Evaluation of

Proposed "Rural Family Grain Storage Project"

By CARE In Chad

Author: Dr. Do Sup Chung, Associate Professor, Kansas State University.

Figure 5. Detailed design plan of the proposed silo (top view and reinforced base).

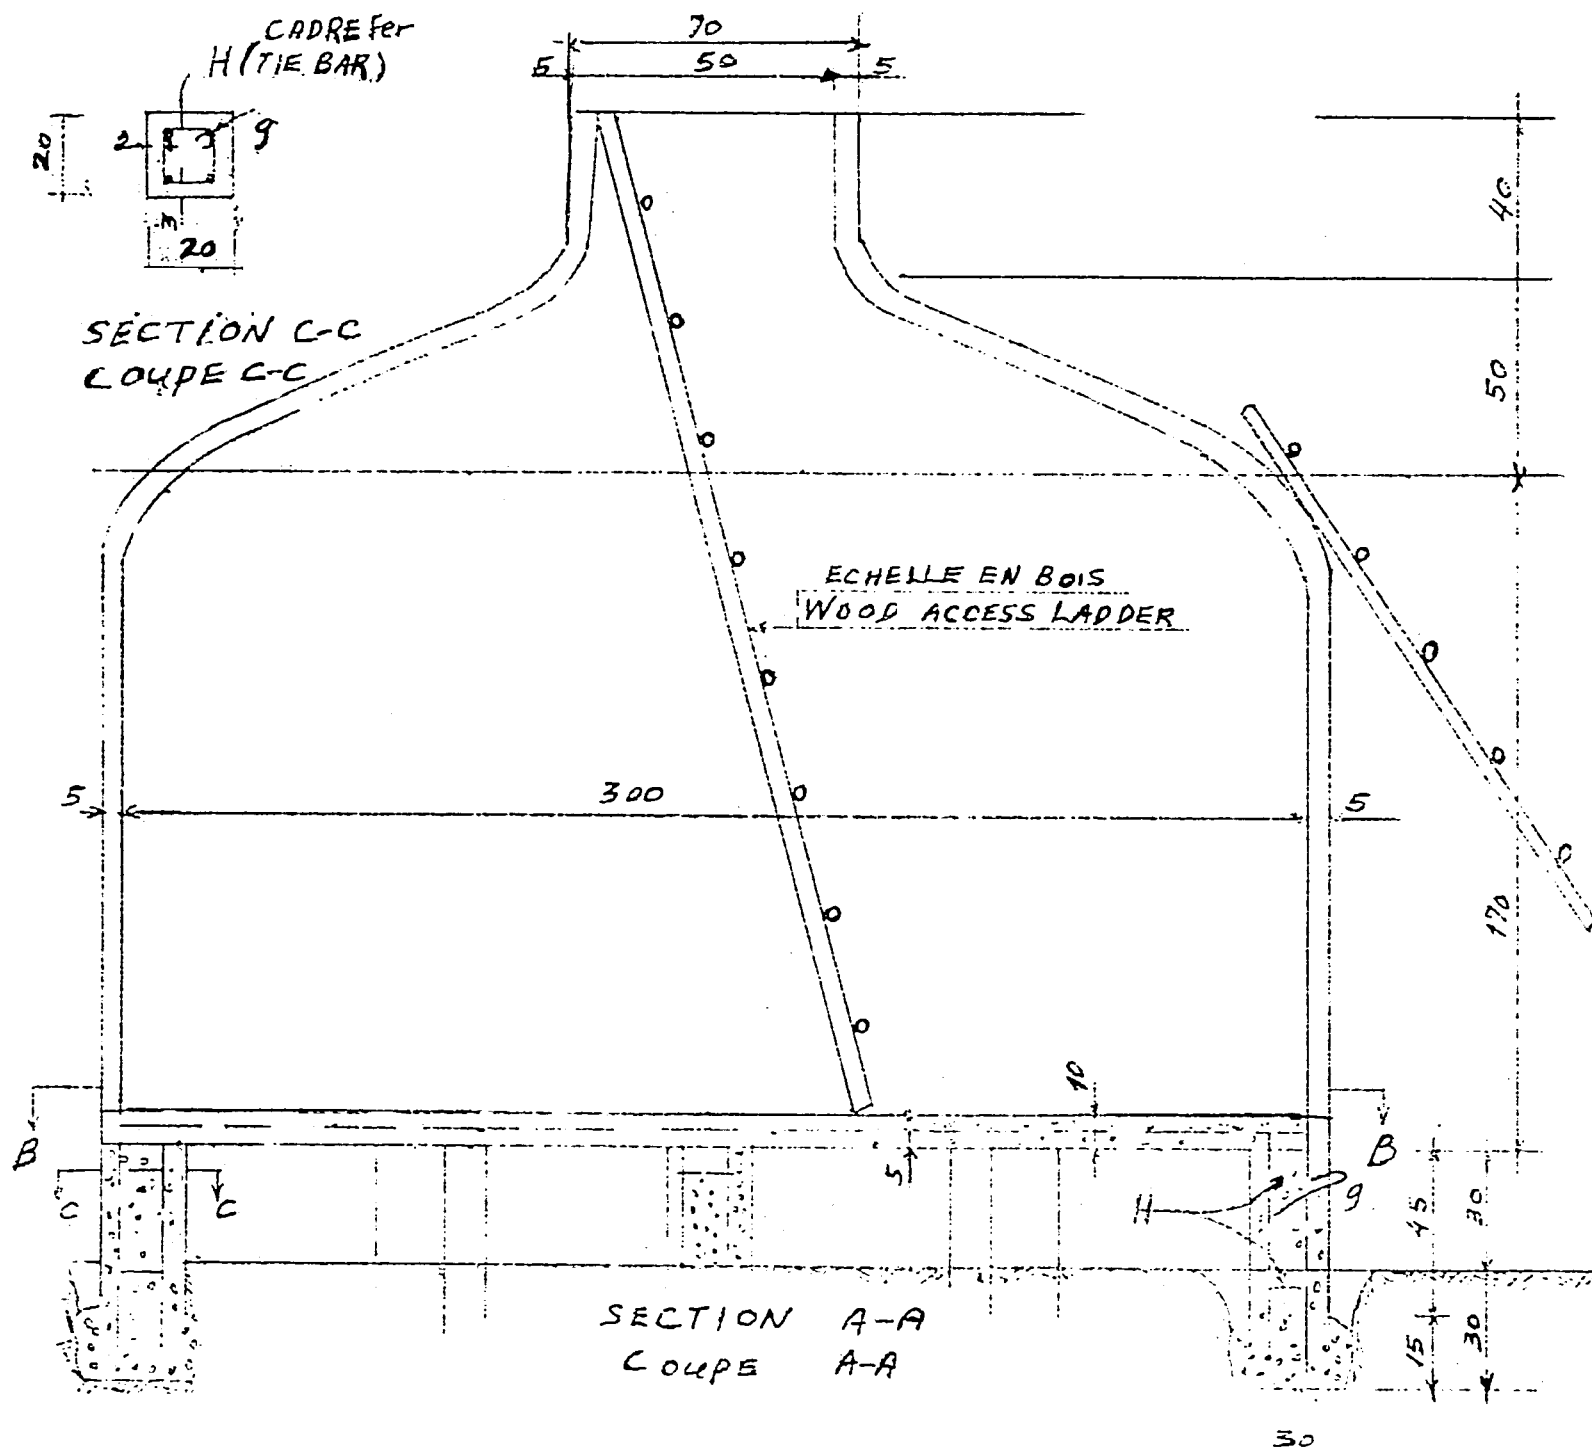
It should be noted that there are obvious errors in the overall silo dimensions given in the original proposal. It yields only 0.57 ton capacity. The original silo design was revised and checked by an engineer. The revised silo design, materials and labor costs are given below:

Evaluation of detailed design of concrete base and footings showed that the concrete mixture used was 1 (cement) : 5 (sand) : 3 (gravel). It appeared to be a coarse mixture for the base and footings. It would be better to use a finer mixture such as 1 (cement) : 3 (sand) : 4 (gravel). There are some errors in evaluating the amounts of cement, sand and gravel needed for constructing the base and footings.

According to the figures of the mixture given in the proposal, the concrete mixture would yield 40 ft^3 . However, the actual volume of the concrete mixture (1 : 5 : 3) needed to construct the base and footings are 32.6 ft^3 . Therefore, about 7 ft^3 extra volume of concrete mixture is used for estimating the cost of construction. Based on the actual volume needed for the proposed design of 32.6 ft^3 , the amount of cement needed is five sacks (5 ft^3). It is suggested that an additional 20 percent over the estimated amount of the cement should be used because of the poor quality of cement available in Chad. Thus the total amount of cement needed is six sacks rather than eight sacks shown in the proposal. The volumes of sand and gravel needed are 25 ft^3 (0.708 m^3) and 15 ft^3 (0.425 m^3), respectively. Therefore, about a \$37 savings from the total unit construction cost will be realized.

If one uses a finer concrete mixture (1 : 3 : 4) as suggested by this reviewer, the total amount of the cement needed is 6.7 sacks which included an additional 20 percent cement. The volumes of sand and gravel needed are 16.8 ft^3 (0.48 m^3) and 22.4 ft^3 (0.63 m^3), respectively. The total cost of a concrete mixture of 1 : 3 : 4 needed for one 8-ton capacity silo would be about \$122, as opposed to \$142 for the revised design of the silo given in the proposal. Thus, about \$20 savings is realized even if one uses a finer mixture. Therefore, it is suggested that the budgets in the proposal should be revised accordingly. Detailed calculations showing the above problems are included in the Appendix.

proposed silo does not have an unloading port or door, causing inconvenience in loading and unloading the grains.

A metal cap or plastic cover should be provided to close the man-hole at the top. Also a straw cover should not be overhung below 60 cm from the ground (note that some rodents can jump 60 cm from a standing position). The bottom of the straw cover should be curved so that water would not directly drip on the walls of the silo.

1. 3m-inside diameter, 2.5m-height (base plate to the top of manhole) and 5cm-thickness, clay pot.
2. The legs are sunk 30 cm into the ground and 30 cm above the ground - seven legs (reinforced concrete).
3. The base plate is 10 cm thick (reinforced concrete).
4. Straw cover.
